Secondary Fuel Filter
D11
VAH

FSB 233-005, Secondary Fuel Filter

(April 2015)

Potential tie rod contact point

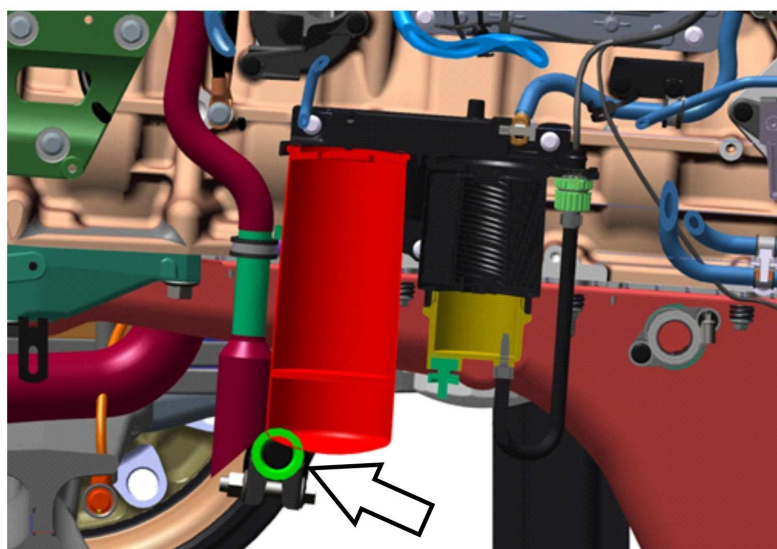
Under certain driving conditions, the secondary fuel filter in the VOLVO VAH D11 engine applications built from November 10, 2013 to March 27, 2015 may potentially be damaged by suspension tie rod interference with the bottom of the filter due to 14 mm lower ride height than earlier chassis builds.

If a customer reports damage to the secondary fuel filter, part number 21879886 (long), replace it with part number 21632237 (91 mm shorter) or an equivalent filter of this length. This filter is also recommended even if no evidence of contact is noted on this chassis arrangement, due to the potential of contact based on load and road conditions. The shorter filter is the current VAH with D11 engine production arrangement starting March 27, 2015. Current published service intervals for this filter replacement still apply.
